Addendum No. 02

Name of Work: *Design and Construction of Civil and Buildings Works including Testing and Commissioning on Design-Build Lump Sum Price basis for Double Line High Speed Railway for Mumbai Underground Station, Cut & Cover Tunnel and Shaft -I from MAHSR Km. -0.255 to Km. 0.775 at Bandra-Kurla Complex in the State of Maharashtra for the Project for Construction of Mumbai-Ahmedabad High Speed Rail*

Date: 13.03.2020

IFB Number: Package No. MAHSR-C-1

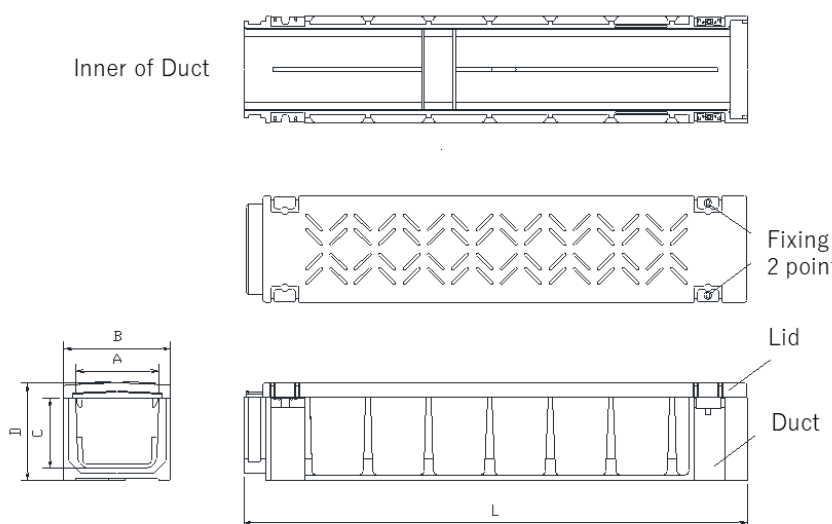
26.	Part 2, Section VI-3, Division 02000, Sub-Clause 7.7.1, Item b) Page 50 of 72	<p>b) Cable duct for LCX</p> <p>(i) Cable duct for LCX shall be made of polyethylene, and polypropylene, which in total shall constitute 63%±5% of the material, and admixture of inorganic material, which shall constitute 37%±5%. Any other alternative material which fulfils the Employer’s Requirements can be proposed by the Contractor. The hazardous materials and substances that generate dioxin and other toxic gases shall not be used. The characteristics of material of the cable duct shall be considered for the influence on radio wave transmission.</p> <p>(ii) The shape and dimensions of cable duct for LCX are as shown in Figure 3 and Table 9. Detail inner and exterior structure dimensions shall be as shown in the attached drawing.</p>	<p><Replace the existing Sub-Clause with the following></p> <p>“b) Cable Duct for LCX at Shaft-1</p> <p>i) In the case of LCX cable duct at <i>Shaft-1</i>, as the duct shall not have metal reinforcement so as not to affect radio wave transmission, the concrete shall be Glass fibre Reinforced Concrete (GRC) and the fibre used shall be alkali-resistance glass fibre. The cement used shall not have a chloride ion content of more than 0.30 kg/m³.</p> <p>ii) The pull-out strength of the bolt-insert for the LCX cable ducts shall be at least 3kN/bolt.</p> <p>iii) The LCX cable duct shall have radio wave transmission range for VHF band (30MHz~300MHz) and for UHF band (300MHz~3GHz). The transmission is influenced by rainwater/moisture content in the cable duct and appropriate measures shall be taken to mitigate the risk of moisture ingress, as per the approved method statement.</p> <p>iv) GRC material: The alkali-resistance glass fibre used in LCX cable ducts, shall be in lengths of 13-19 mm, with diameter in the range of 18 μm ± 2 μm, shall be clean and without any cracks; shall be dry having water-content less than 0.5%; and shall have a zirconia content of not less than 16.0%. The Contractor shall submit the material certificate from the Manufacturer to the Engineer for approval.”</p>

Item No.	Refer Para No.	Original/As Existing	Revised												
		 <p style="text-align: center;">Figure 3: Shape of Cable Duct for LCX</p> <p style="text-align: center;">Table 9: Dimensions of Cable Duct for LCX</p> <table border="1" style="margin-left: auto; margin-right: auto; border-collapse: collapse;"> <thead> <tr> <th style="text-align: center;">Dimens ions</th> <th style="text-align: center;">A</th> <th style="text-align: center;">B</th> <th style="text-align: center;">C</th> <th style="text-align: center;">D</th> <th style="text-align: center;">L</th> </tr> </thead> <tbody> <tr> <td></td> <td style="text-align: center;">170 ± 8</td> <td style="text-align: center;">220 ± 8</td> <td style="text-align: center;">145 ± 8</td> <td style="text-align: center;">200 ± 10</td> <td style="text-align: center;">1035 ± 10</td> </tr> </tbody> </table>	Dimens ions	A	B	C	D	L		170 ± 8	220 ± 8	145 ± 8	200 ± 10	1035 ± 10	
Dimens ions	A	B	C	D	L										
	170 ± 8	220 ± 8	145 ± 8	200 ± 10	1035 ± 10
